Corrigendum 5 dated Dec' 06, 2019 to Tender Specification BHEL PSSR SCT 1866 for Structural Works of Coal Handling Plant and Ash Handling Plant area and Non-plant structure of Unit 1 & 2 (Package 2) for 2 x 660 MW Udangudi Supercritical Thermal Power Project, Tuticorin, Tamil Nadu

1) Some of the Bidders had raised queries for clarification in the published Tender Specification and BHEL's clarifications are furnished below:

SEA WATER OUTFALL PUMP SECTIONAL VIEW - 'A-A'
SCALE 1:160

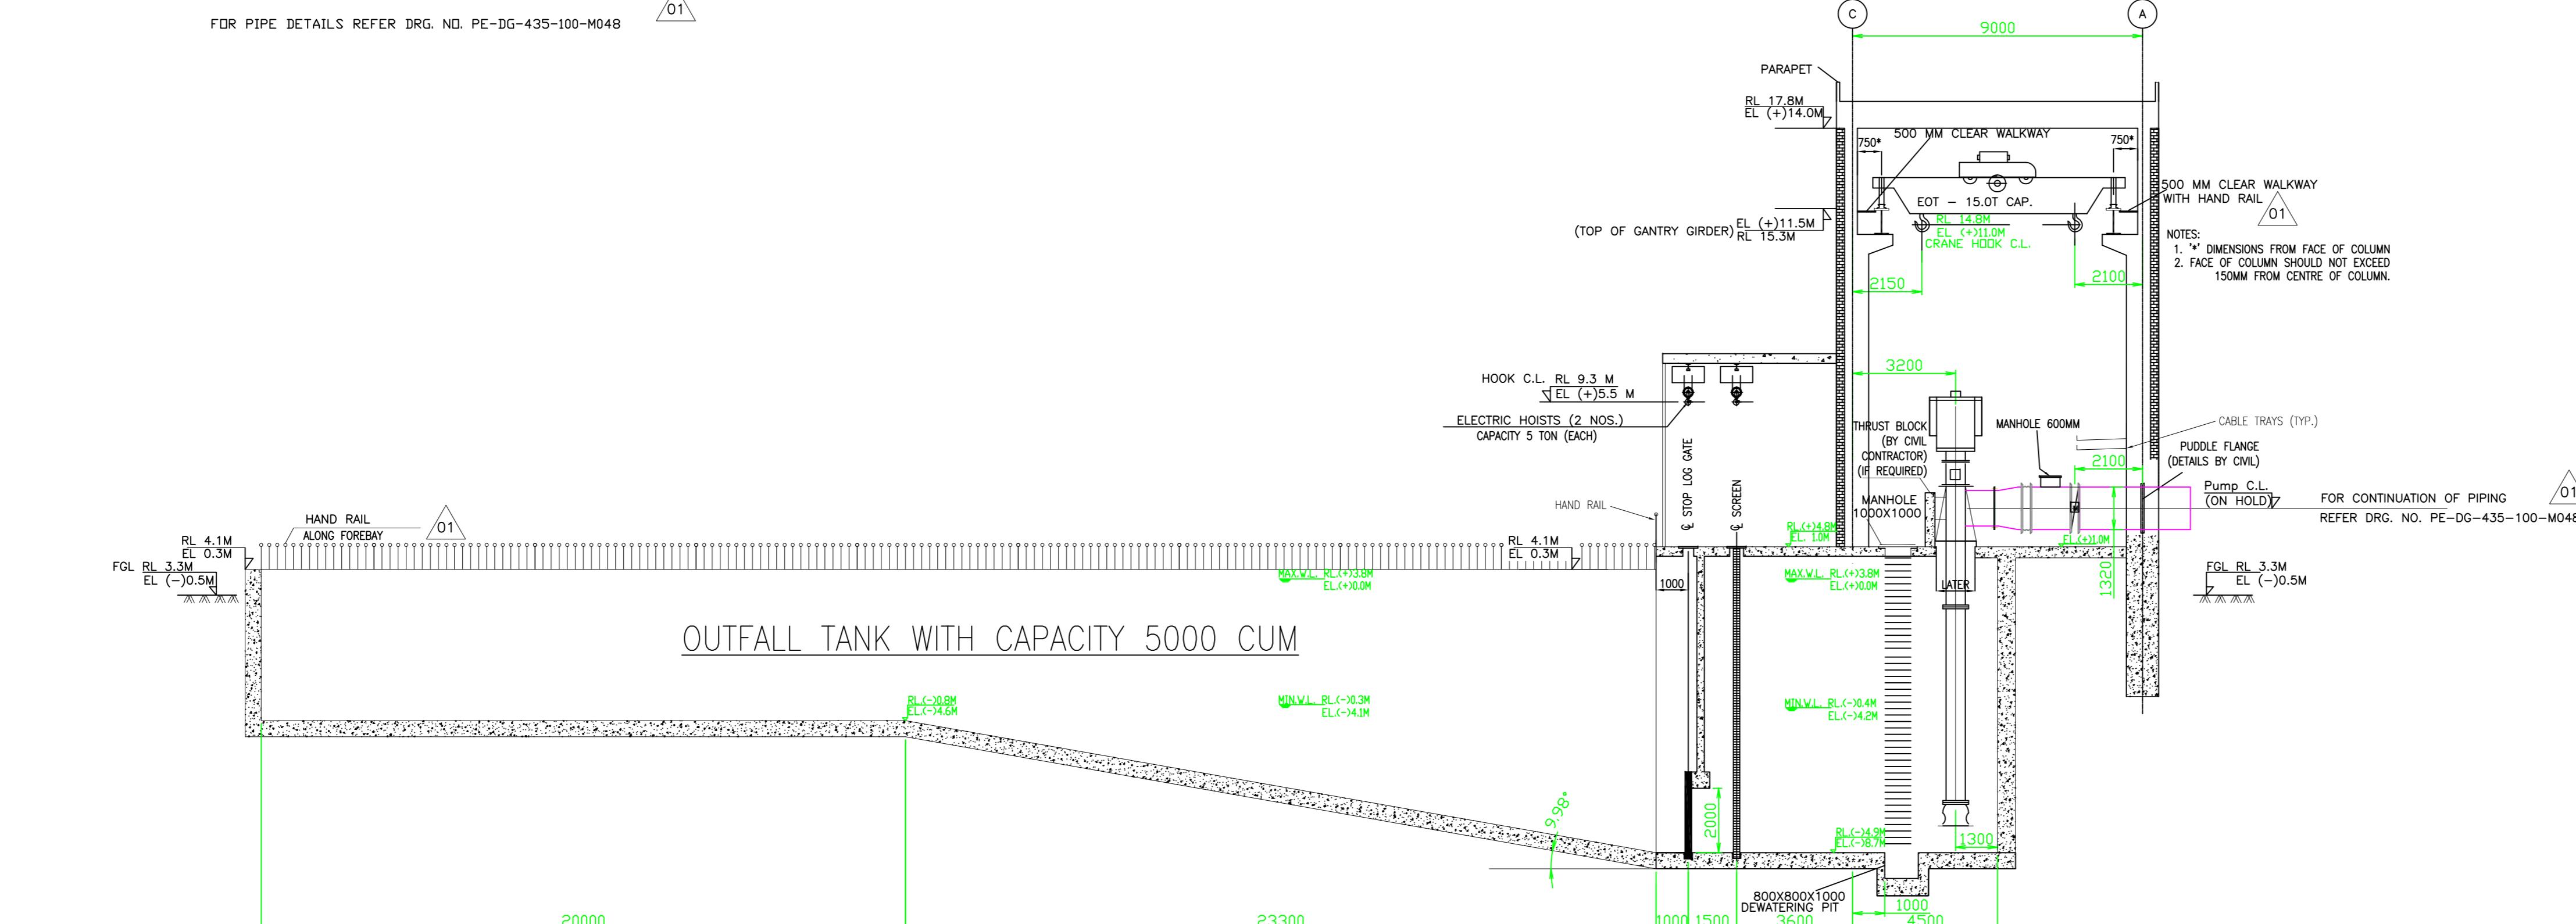
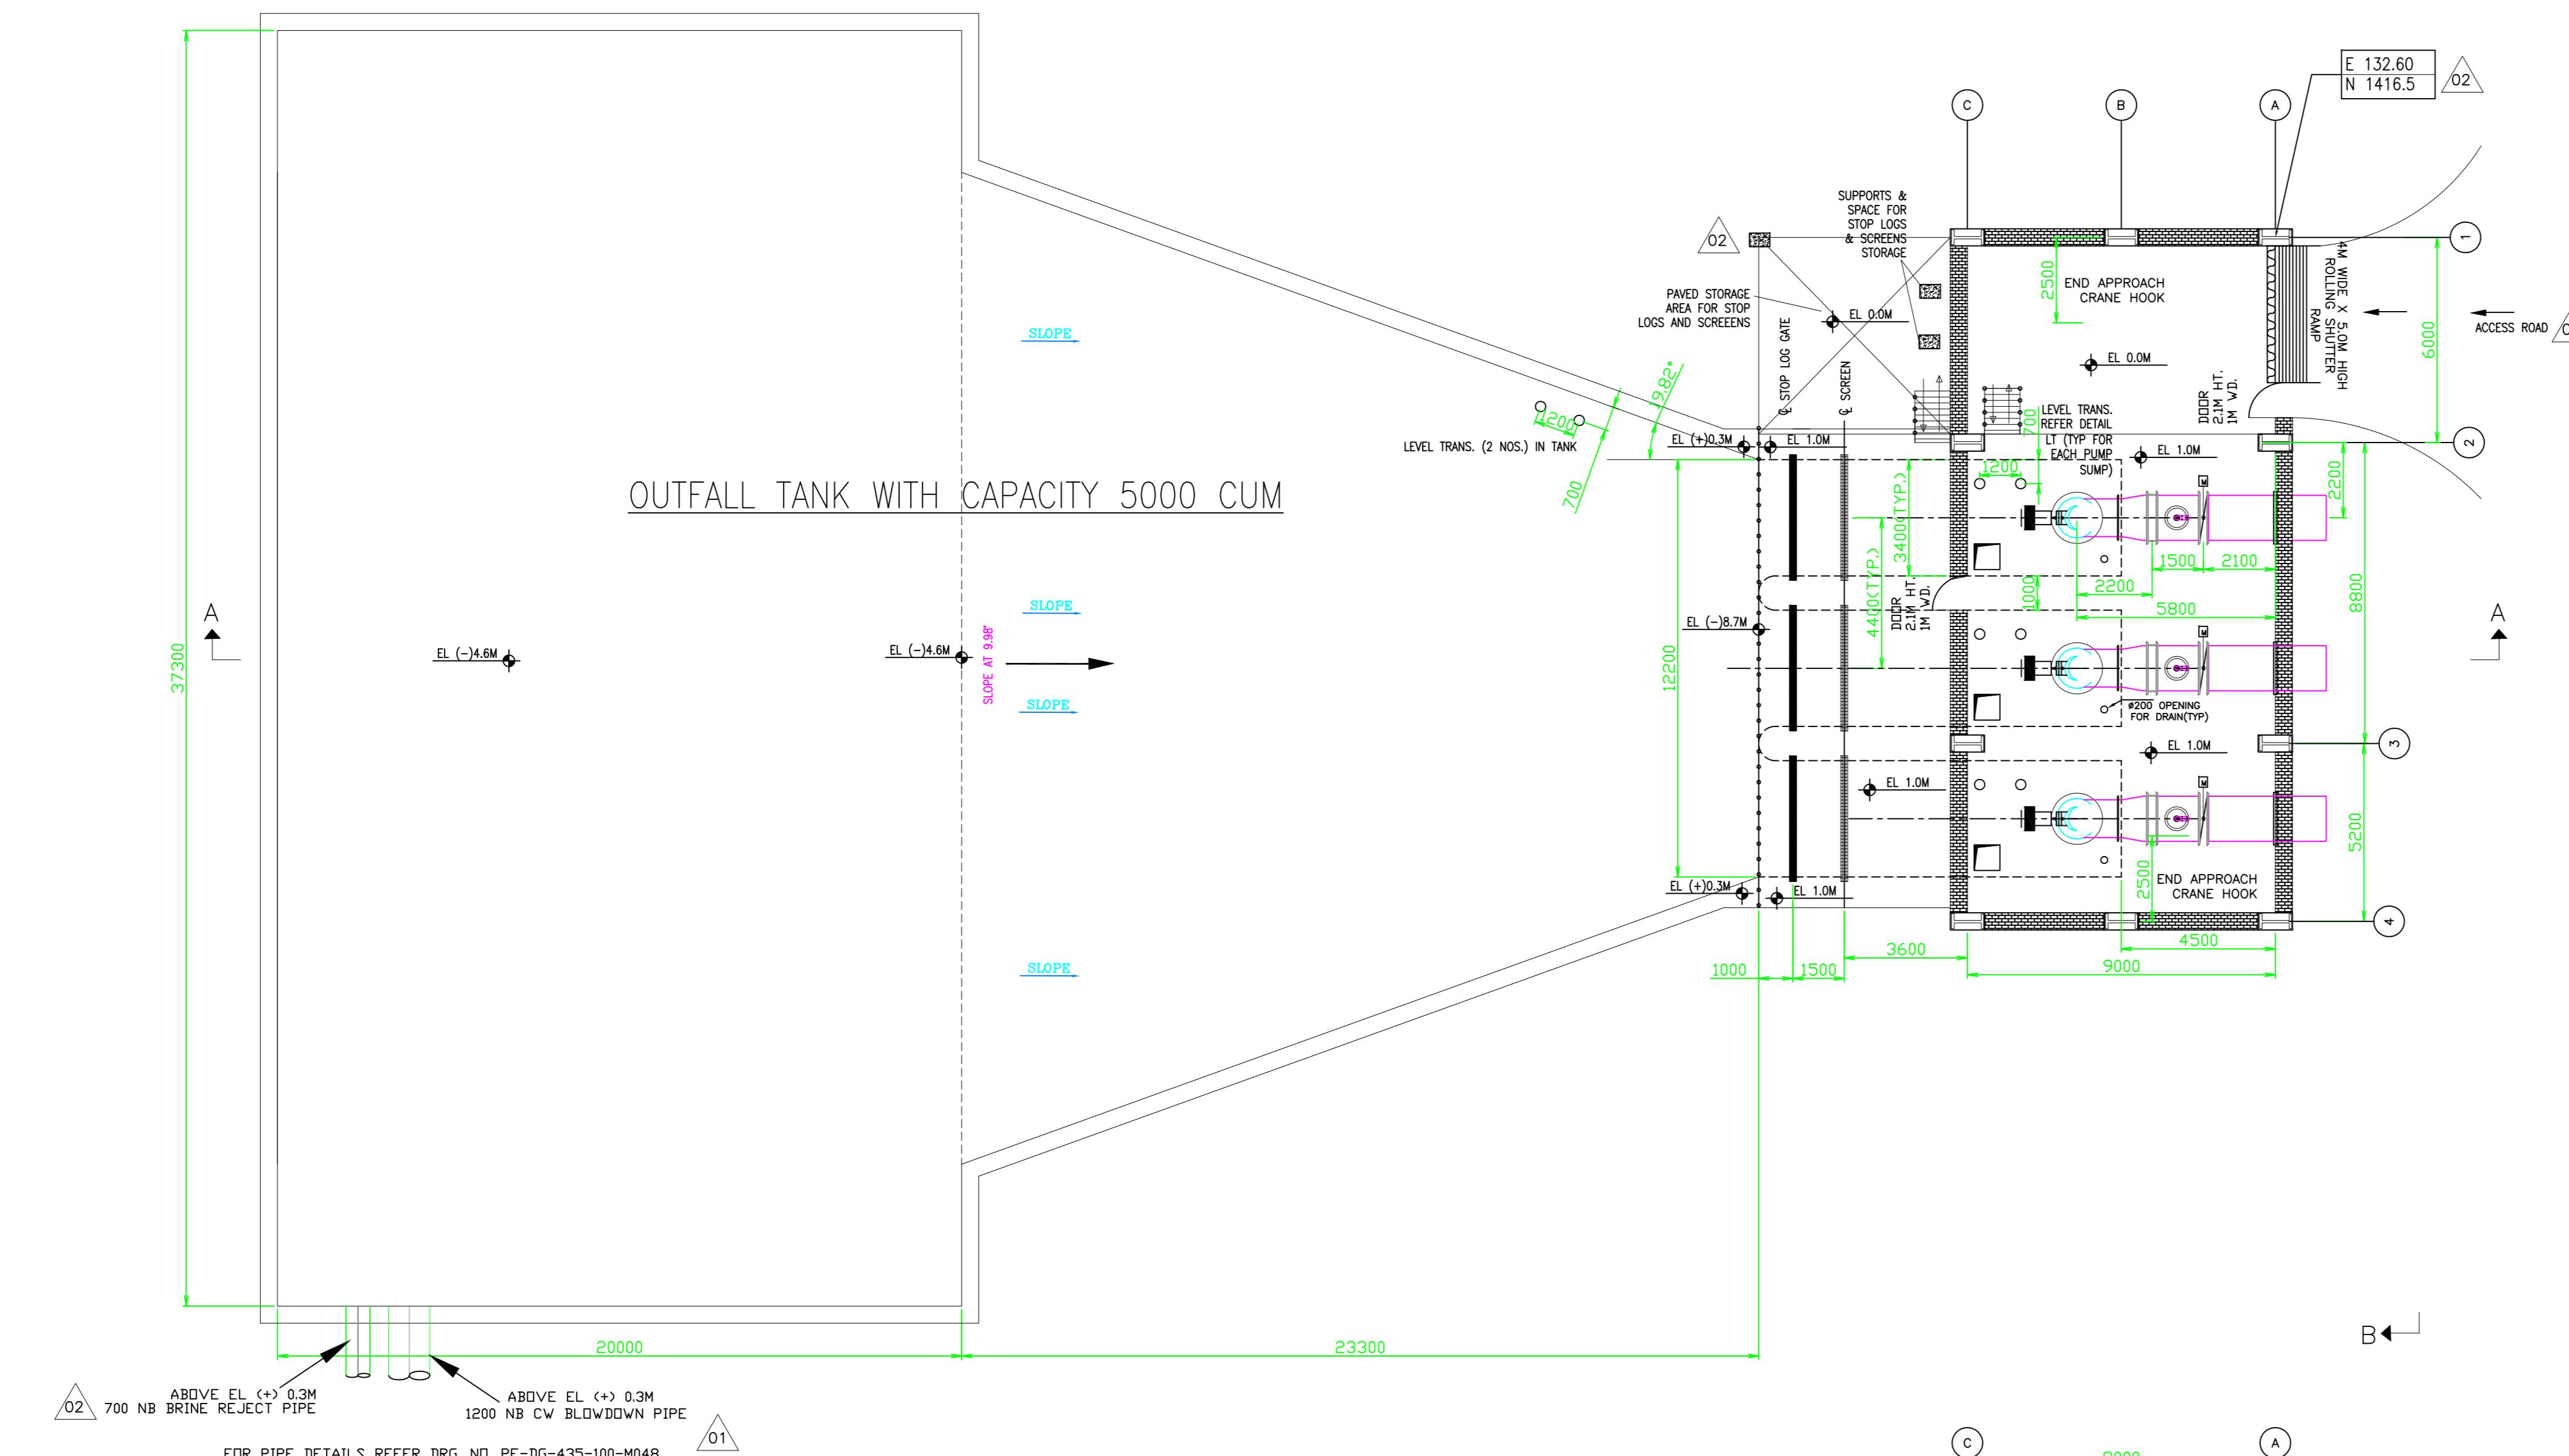
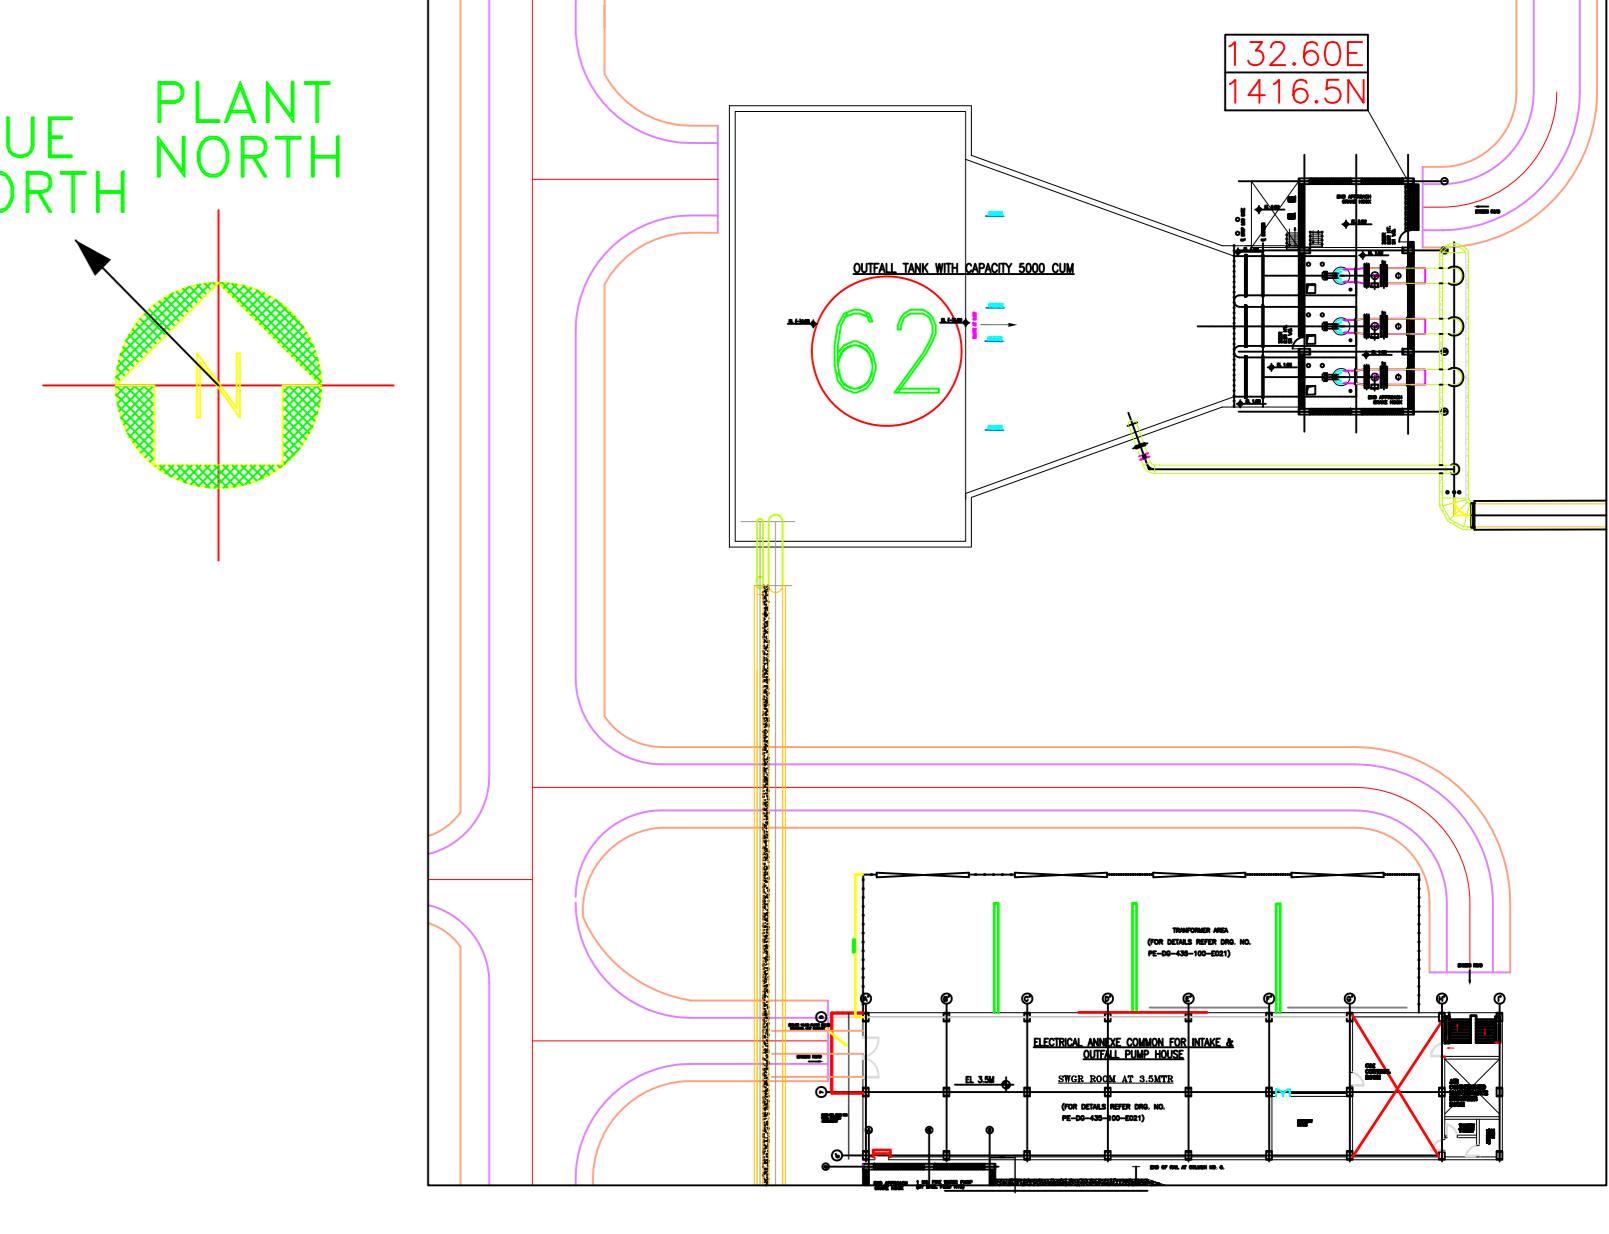
Quantity of each type of stop log and coarse screen	Refer Pricebid
9	Price Bid	Item A2329, B2329 , A2332, B2332	Size of each type of gate and screen	Refer enclosed drawing for information
			Max water level	
			Minimum water level	
			Sill level	
			Operating floor level	
			Opening of wire mesh and dia of wire mesh	
10	Part C: Bill of Quantities	Item no. 2303	The weightage allocated to this item seems to be unbalanced Weightage shall be revised for this item.	Tender Condition Prevails
